# **Statement of Response to An Bord Pleanála Opinion**

**A Proposed Strategic Housing Development**

**Belgard Square East, Belgard Road and Blessington Road,  
Tallaght, Dublin 24.**

**Ravensbrook Ltd.**

Figure 9.1: Tallaght Core Retail Area and Opportunity Sites.

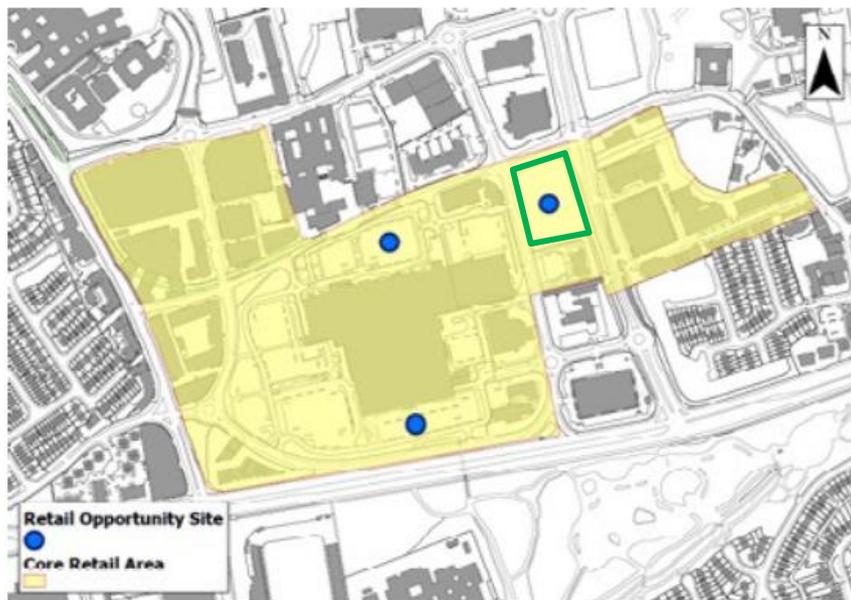
- 2.4. The first item to be addressed relates to compliance of the proposed development with the South Dublin CDP and Tallaght LAP.

*1. A detailed statement of consistency and planning rationale, outlining how in the prospective applicant's opinion, this primarily residential development is in compliance with the policies of the County Development Plan for this area. Such statement should have regard in particular to the "Town Centre" land use zoning objective and the identification of this as a Retail Opportunity Site, as well as the provisions of section 2.4.2 of the LAP relating to Mixed Use Frontage in such locations.*

- 2.8. The subject site is identified as a 'Retail Opportunity Site' within the Core Retail Area of Tallaght, shown below in extract of Figure 9.1 of the draft South Dublin CDP 2022-2028 (indicative site location shown in green).

- 2.10. The subject site is identified as an 'Retail Opportunity Site' located within the Core Retail Area of Tallaght town centre and the proposed development will directly facilitate the redevelopment of the site for a mixed-use scheme including retail. The proposal includes c. 2,289 sqm of commercial use, including c. 1,913 sqm of retail and retail-related services within a mixed-use development that comprises 310 BTR apartments. This is comprised of the following:

**Figure 2: The Centre Urban Structure Extract Figure 3.3 of Tallaght LAP**

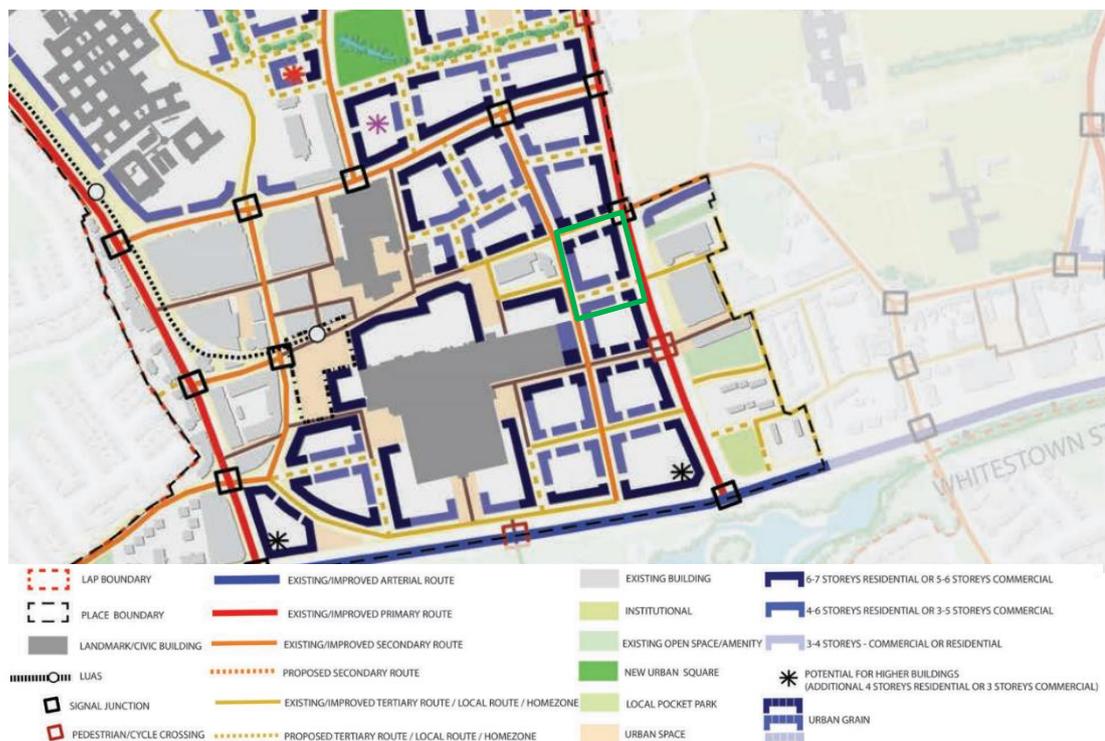
- 2.40. The third item to be addressed relates to traffic and transport:
3. *Further clarification and elaboration for the documents as they relate to the design and function of the proposed Tertiary Road linking Belgard Road with Belgard Square East. The intent with regard to the taking-in-charge of this road should be clearly stated.*

2.42. The design and function of the tertiary route has been subject to discussions with the South Dublin Roads Department in preparation for this submission following the Opinion of the Planning Authority and the Board. The design of the tertiary route has been refined to that proposed at pre-application stage, with vehicular access restricted to the western point of entry at Belgard Square East to access the drop off / set down parking area at the western perimeter of Block C. The remainder of the route will be for walking and cycling, with emergency and service vehicular access permissible and a single disabled access parking space located to the south of the route and a set down / layby to the north to facilitate refuse collection.

2.44. The proposed function of the tertiary route will ensure a safe and effective route which will respond appropriately to the requirements of the LAP and limit movement through the site to cyclists and pedestrians only. Alterations to the design of the shared street arrangement, cycle access junction at Belgard Road and the design and location of visitor and long-stay cycle parking arrangements have also been undertaken following discussions with the Planning Authority in March 2022.
